Docket Item # 1
BAR CASE # 2011-0361

BAR Meeting
January 18, 2012

ISSUE: Alterations (Basement Walkout Installation)
APPLICANT: Stanley and Sandra Bysshe (Byron Woods, Agent)
LOCATION: 732 South Royal Street
ZONE: RM / Residential

Figure 5: Site Plans

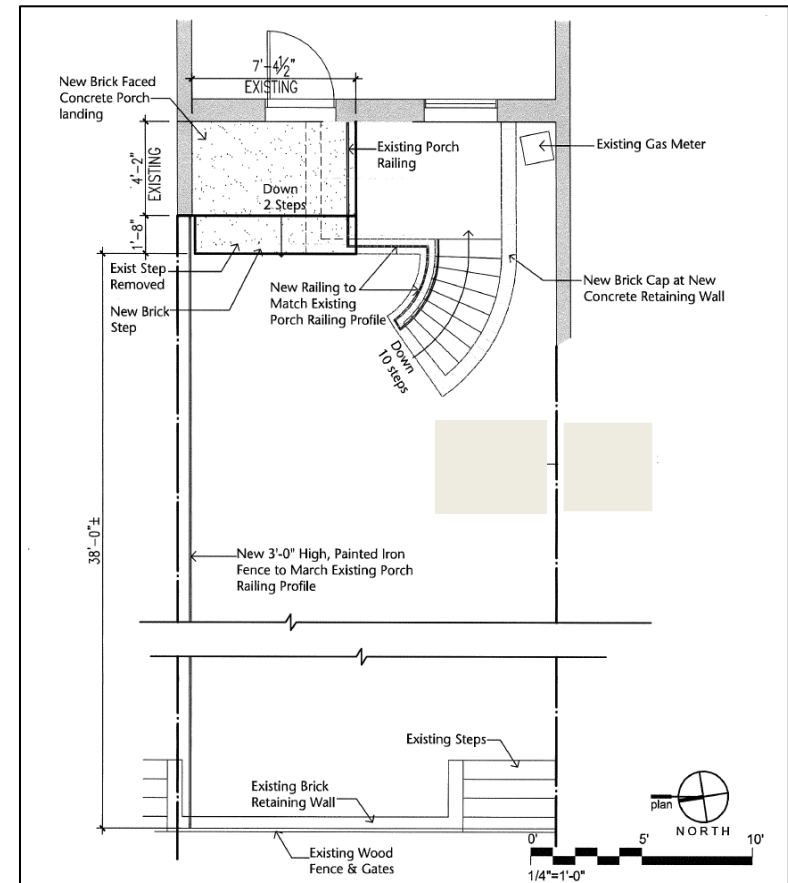
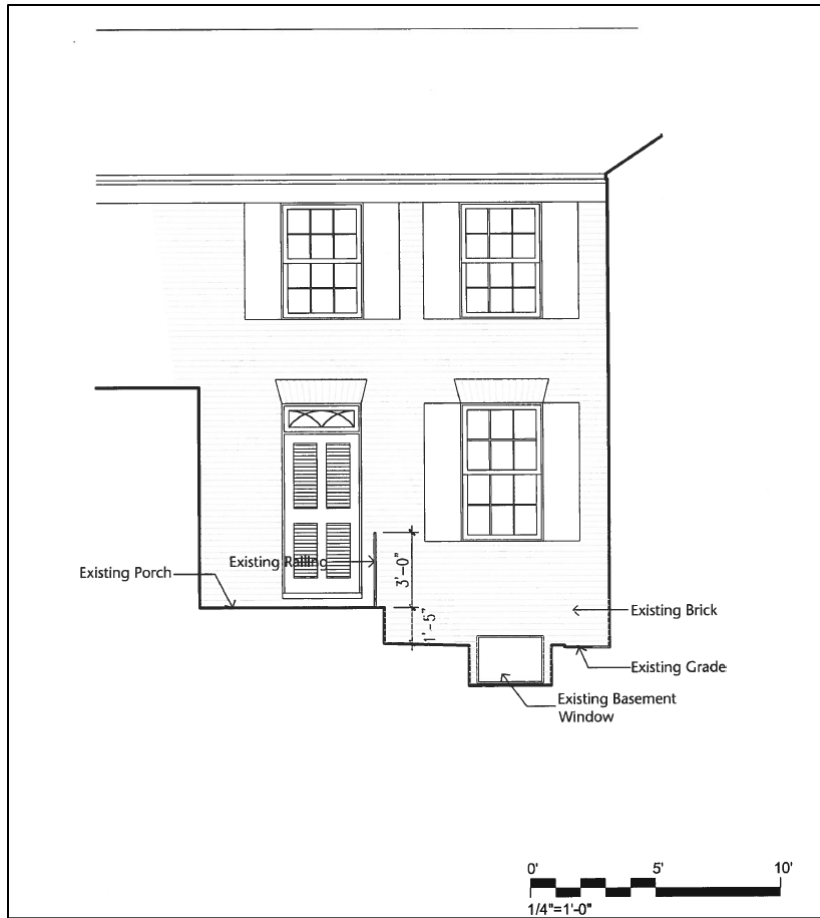
- Demolition of the existing front stoop.
- Excavation of the earth below the front stoop and around the existing basement window.
- Installation of a new retaining wall, concrete slab and egress staircase leading to grade. (A new floor drain will be tied to basement sump).

- Enlarge the existing basement window to create a new opening for a new wood six-panel door.
- Re-construct the brick front stoop with brick veneer at the existing size and elevation. Re-install the existing iron guard railing.

- Face the top of the concrete wall with brick to match the front stoop.
- Install a new, iron guard railing to match the existing stoop guard rail along the concrete wall, as required.

- Install a new 3' high painted iron fence along the north property line in the front yard. The fence will extend from the existing white picket fence along the street line to the house and will match the simple design of the existing guard rail.

- Relocation of the existing HVAC condenser to the rear yard (the condenser in this new location will not be visible from a ROW.)

Figure 6: Front Elevations

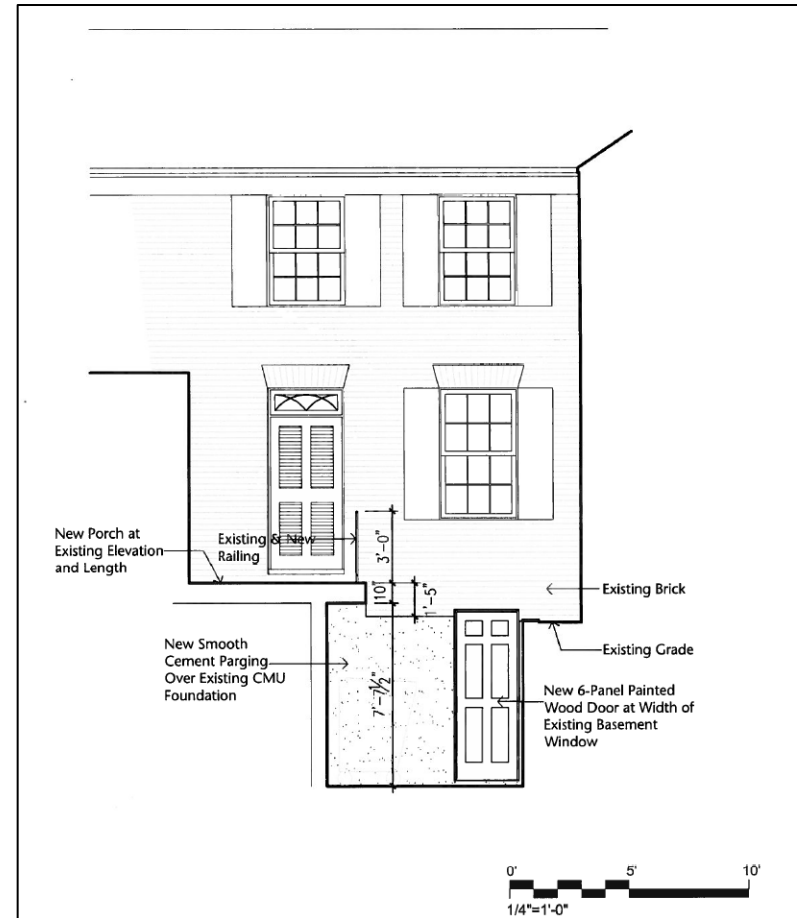
The basement walkout, as proposed, does not overwhelm the existing building, respects the architectural integrity of the original structure and the historic character of the Yates Garden's development and by utilizing a curvilinear design creates delineations between the historic house and the alteration. Staff recommends approval of the proposed basement walkout, as submitted.
